**ADDENDUM NO. 1**

ISSUE DATE: **August 21, 2023**

RE: **Camp Randall Stadium East Bowl Recoating  
University of Wisconsin - Madison  
Madison, Wisconsin**

**UW-Madison Project No. 0022-2304  
UWSA Project No. A-22-020**

7 SIDEWALL SECTION AT VOMITORIES, SECTION  
SCALE: 3/4" = 1'-0"

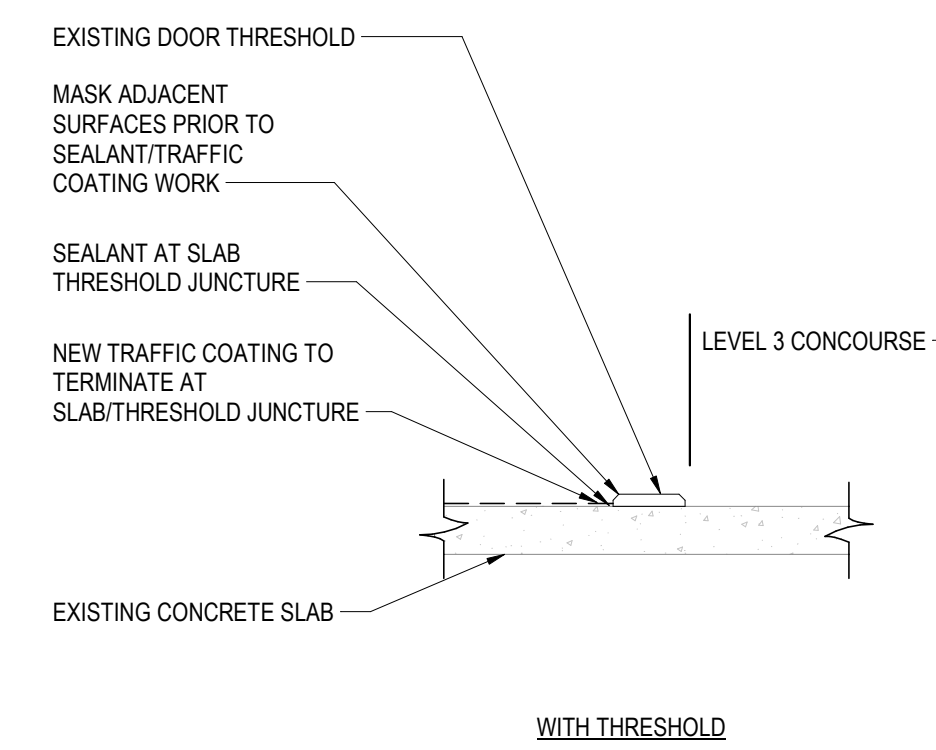
3. Pre-Bid Question: Vomitory walls should be coated with breathable paint, not with traffic coating. Traffic coating will not allow the concrete to breathe. Existing paint on inside walls of the vomitory are not breathable and coating outside and top would lock in moisture. Please specify an acceptable product.

Response: Details have been updated to terminate coating at base of wall. See detail 7/S200 on Sheet 200 re-issued with this addendum.
